SPARTAN CHASSIS, INC.

RSB05-100-001A

RECALL SERVICE BULLETIN

SUBJECT: Battery Cable and Wire Routing

FIG 2-1

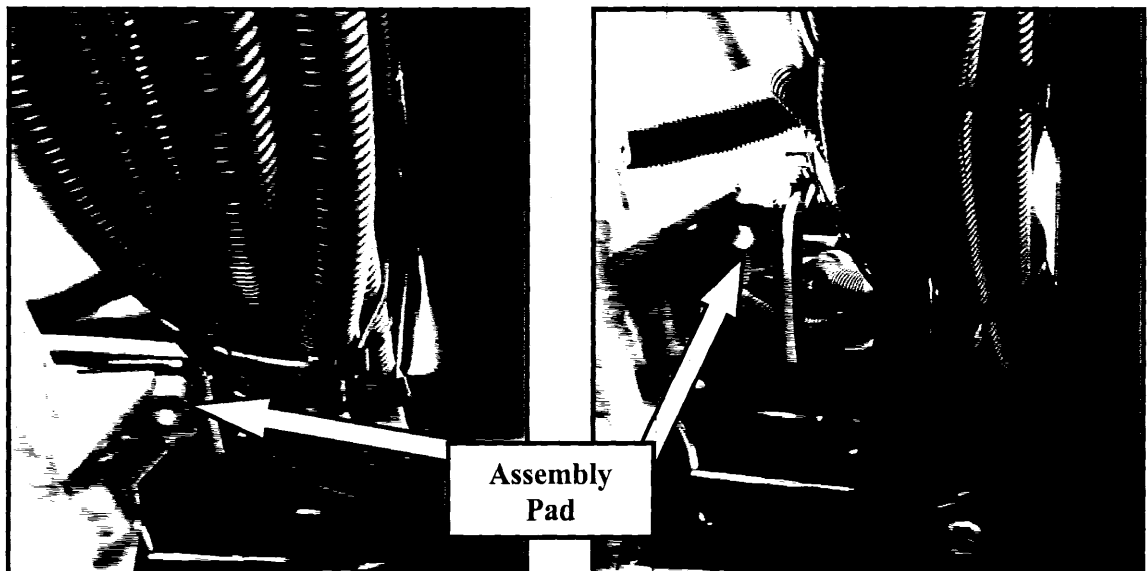
1. Observe all industry safety standards and secure vehicle to allow for rerouting of chassis wiring harnesses and cables.
2. Locate the transmission assembly pads(s). Check for tie straps through the hole in the assembly pad that may be attaching wiring harnesses/cable bundles. If a tie strap(s) is not found through the assembly pad, proceed to step #3.
 - 2a. Refer to FIG. 3-1. If a tie strap(s) is attaching wiring/cable bundle to the assembly pad(s), cut the tie strap and check for any damage to wiring and/or loom; specifically evidence of chafing.

3. Wiring must be secured as shown below in FIG. 2-1. If bundle was previously cut loose from the transmission assembly pad(s), re-bundle using tie straps as shown.
